# 7-ELEVEN

STORE #38421

STATE HIGHWAY NO. 66 & WILLOW BEND  
ROCKWALL, TEXAS 75087

"RECORD DRAWINGS"  
These drawings have been revised to show changes during the construction process reported by the contractor to Evolving Texas and considered significant. This drawing is not guaranteed to be "As Built", but is based on visual inspection and the information available and provided to Evolving Texas  
Date: 10/9/2019 By: *Samantha D. Renz*

NOTE:  
 ALL RESPONSIBILITY FOR ADEQUACY OF DESIGN REMAINS WITH THE DESIGN ENGINEER. THE CITY OF ROCKWALL, IN REVIEWING AND RELEASING PLANS FOR CONSTRUCTION, ASSUMES NO RESPONSIBILITY FOR ADEQUACY OR ACCURACY OF DESIGN.

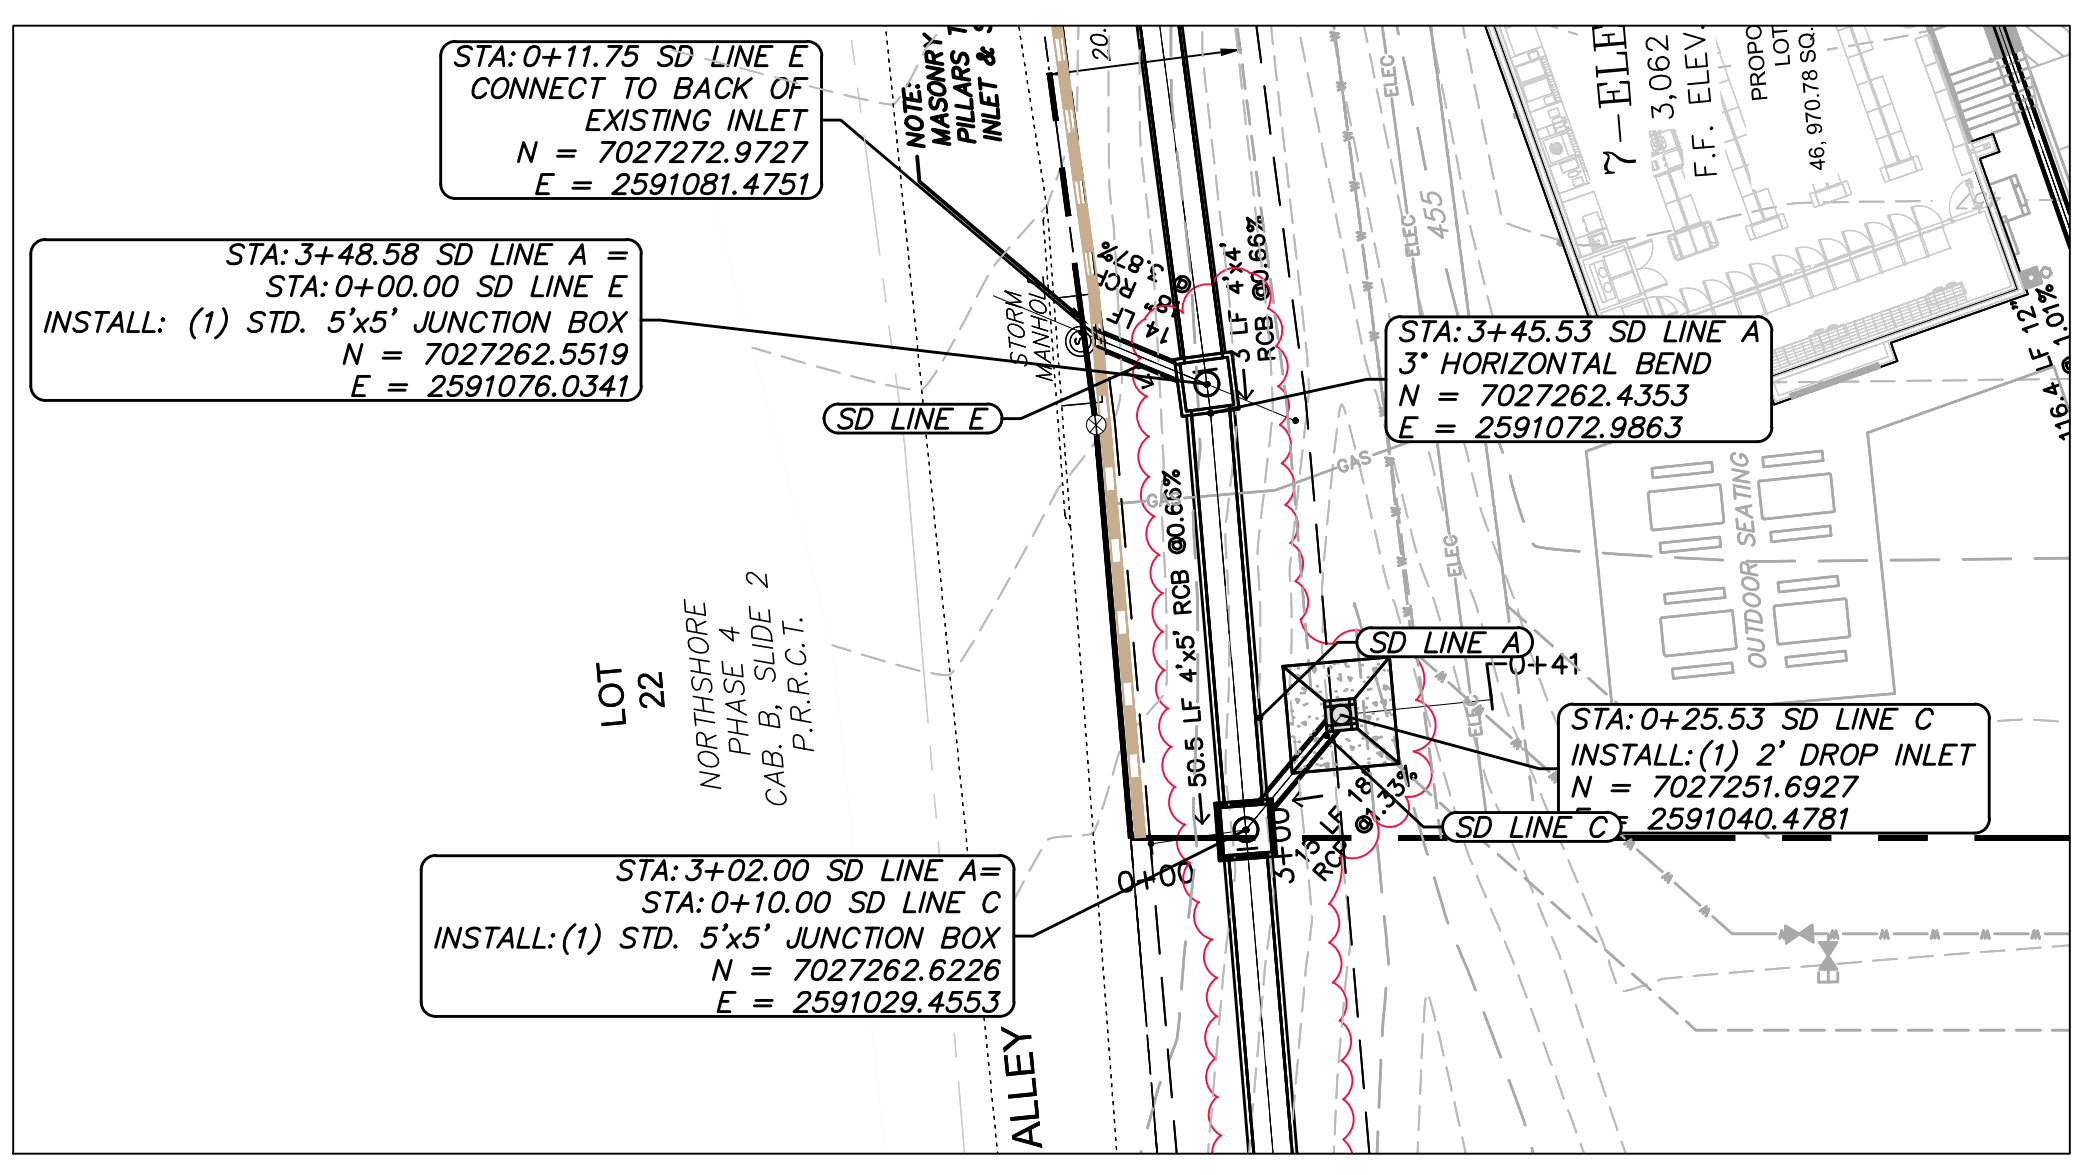
NO.	DATE	COMMENTS
1	1/21/19	Revised slotted drain alignment, P. format of computer enclosure due to shift
2	2/7/19	Revised box culvert size from 4x4' to 4x5' and HGLs
